RE: Acceptance, Closure Summary Reports (CSR) for Partial Closure of RCRA Unit 374.3 - 400 Area and Closure of RCRA Unit 374.3 - 700-800 Area Process Waste Transfer System

CLOSURE SUMMARY REPORT FOR OF RCRA UNIT 374.3 - 700-800 AREA PROCESS WASTE
TRANSFER SYSTEM - SMN-055-05

**RE: Acceptance, Closure Summary Reports (CSR) for Partial Closure of RCRA Unit 374.3 - 400 Area
and Closure of RCRA Unit 374.3 - 700-800 Area Process Waste Transfer System**

Figure 1
IHSS Group 000-4
New Process Waste Lines
(NPWL)
and Valve Vault
Locations

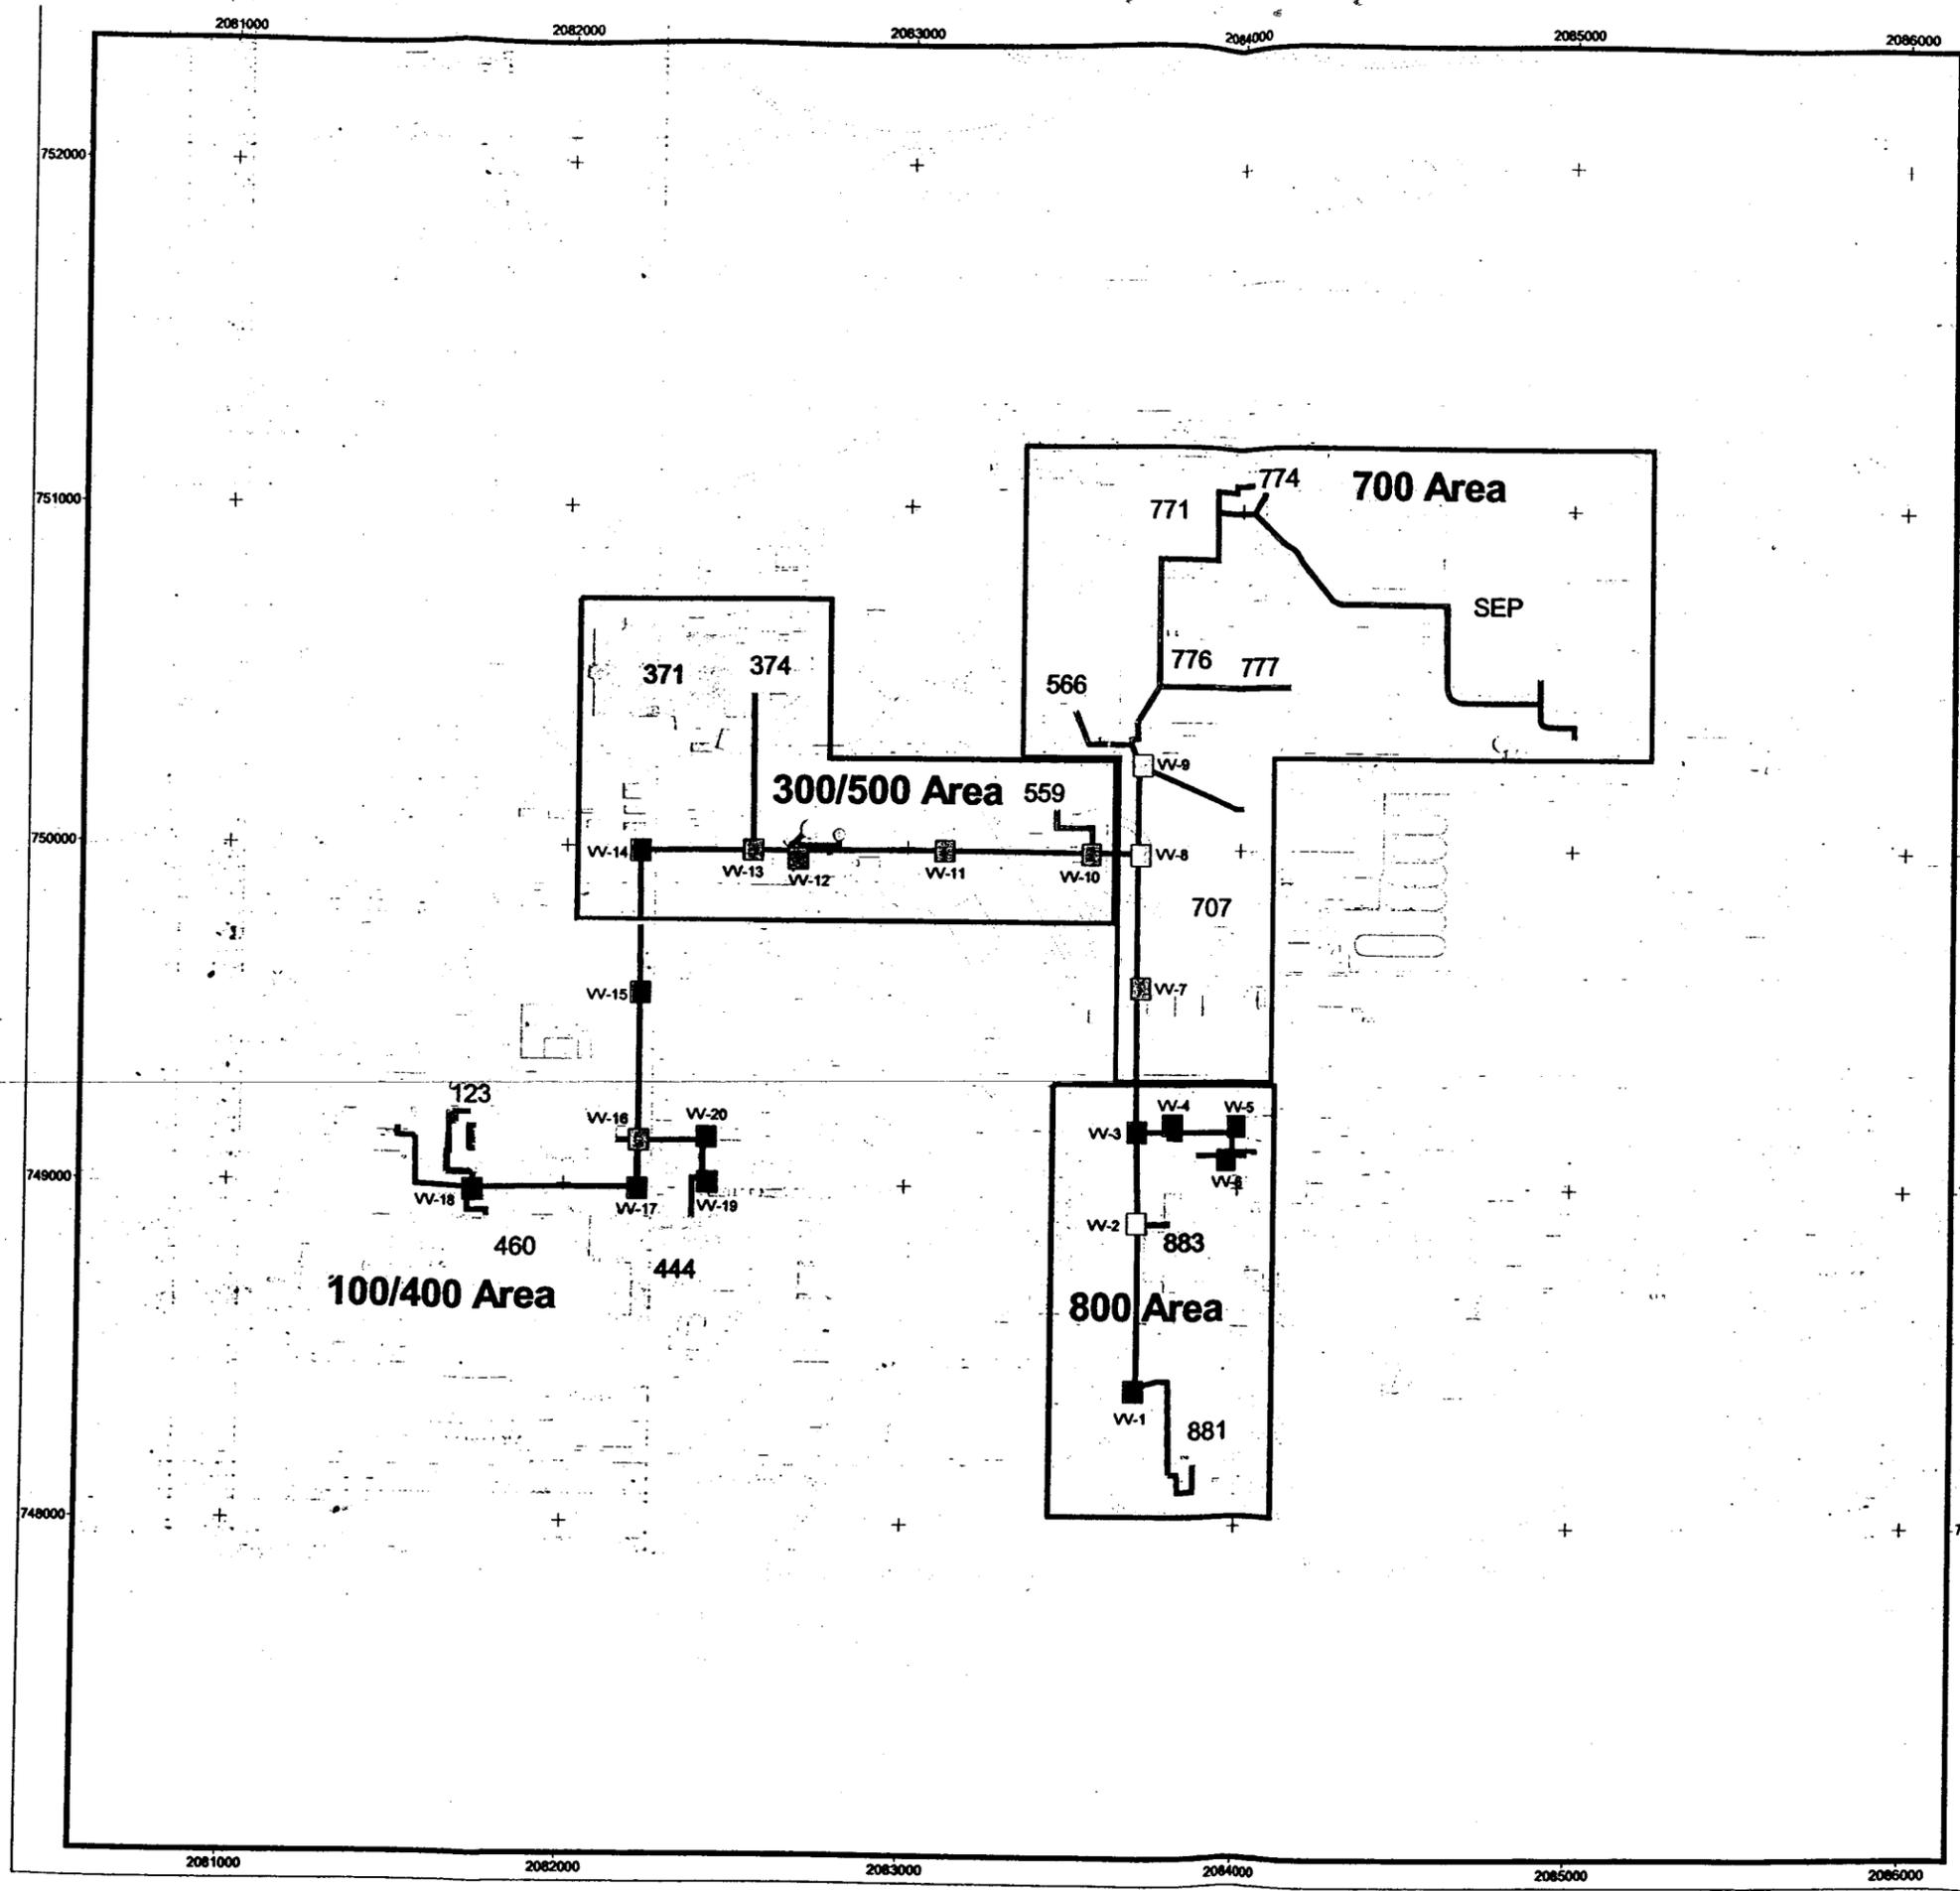
Figure 1 indicates that the line from Building 559 was not part of Unit 374.3 and was left in place. We agree that that portion of the transfer system line was not part of the system but was removed for practical reasons after specific RCRA closure activities had been completed. The line from Building 566 is correctly represented as non-RCRA and was left in place.

Lastly, discrepancies between Figure 1 and Attachment 2 of the 700-800 Area CDD were resolved. Figure 1 correctly excludes an OPWL line from B779 to B776. Further, it correctly shows lines originating in B881, becoming a single line in B887 and extending back through the west side of B881 to Valve Vault 1.

Figure 1 indicates that the line from Building 559 was not part of Unit 374.3 and was left in place. We agree that that portion of the transfer system line was not part of the system but was removed for practical reasons after specific RCRA closure activities had been completed. The line from Building 566 is correctly represented as non-RCRA and was left in place.

Lastly, discrepancies between Figure 1 and Attachment 2 of the 700-800 Area CDD were resolved. Figure 1 correctly excludes an OPWL line from B779 to B776. Further, it correctly shows lines originating in B881, becoming a single line in B887 and extending back through the west side of B881 to Valve Vault 1.
